Ref: DC/21/05468 Full Planning Application - Construction and operation of a 100MW Battery Energy Storage System, and related infrastructure with associated access, landscaping and drainage. Land to the South of Bullen Lane Bramford, Suffolk, IP8 4JD.

CARE Suffolk Report for DC/21/05468

Full Planning Application - Construction and operation of a 100MW Battery Energy Storage System, and related infrastructure with associated access, landscaping and drainage.

Diagram 1: Potential Dispersal Zone

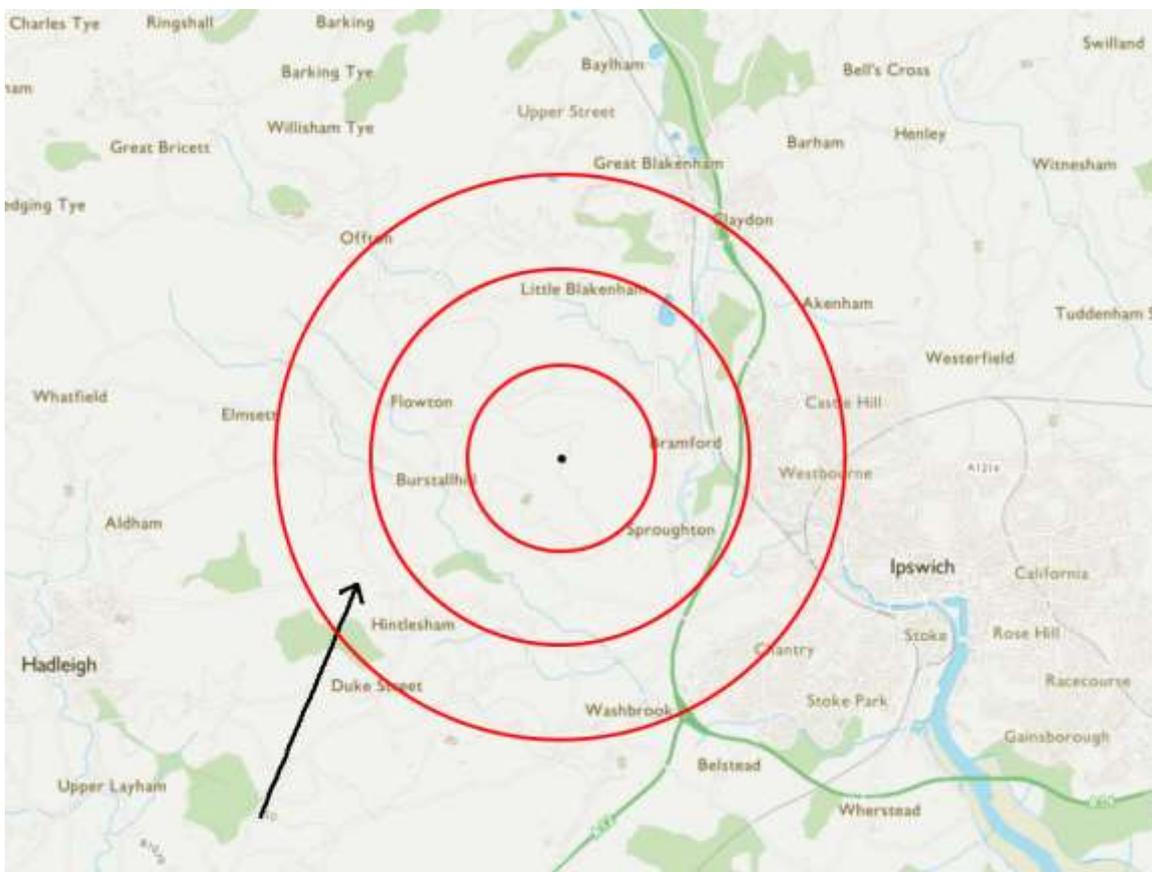
2.11 A potential dispersal zone of these gases is shown in Diagram 1 below. Red circles represent the area based on 10mph, 20mph, and 30mph winds. The arrow shows the prevailing wind direction. The final dispersion zone and direction would further be affected by relative humidity, temperature, atmospheric stability, and the mixing height.
